September 24, 2022

**Subject: Concerns about the Valli Vue LRSA ditch rehabilitation project**

Figure 1. Municipality guidance for streets like those in Valli Vue

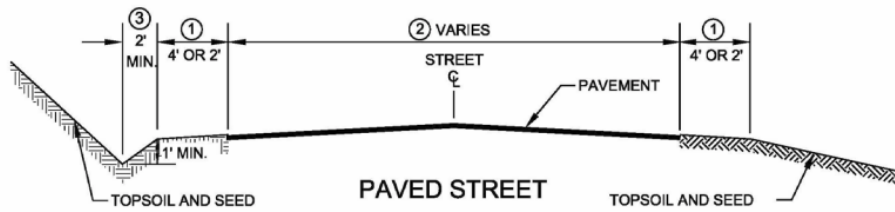
The present ditch configuration is also at odds with the Municipality's guidance for rural streets such as ours (Figure 1). The guidance depicts a 2-foot shoulder approximately flush with the road surface followed by a ditch as shallow as 1 foot lined with topsoil and grass. In practice, a 1-foot shoulder seems typical (as seen on East 99<sup>th</sup> Ave, Homestead Trail, and Meridian Way/Zenith St), and our shoulders were about that wide before excavation. The depth of our ditches was also close to the 1-foot minimum, which could have been achieved with minimal digging. An effective case has not been made to justify the magnitude of the present project in contrast to a much smaller effort that would have conformed with the guidance. Given the safety problems with the current effort, restoration of perceived original contours of nearly 50 years ago is nonsensical. The ditch project should have been based on the current guidance.

1. Restoration of 1-foot shoulders (or greater) as soon as possible, preferably before winter.

2. Reduction of ditch depth to no more than 1.5 feet before topsoil placement, where practical (e.g., away from culverts).
3. Final contouring and cleanup to remove loose rocks and roots and smooth transitions to adjacent landscaping.
4. Addition of a suitable thickness of topsoil and seeding with grass.
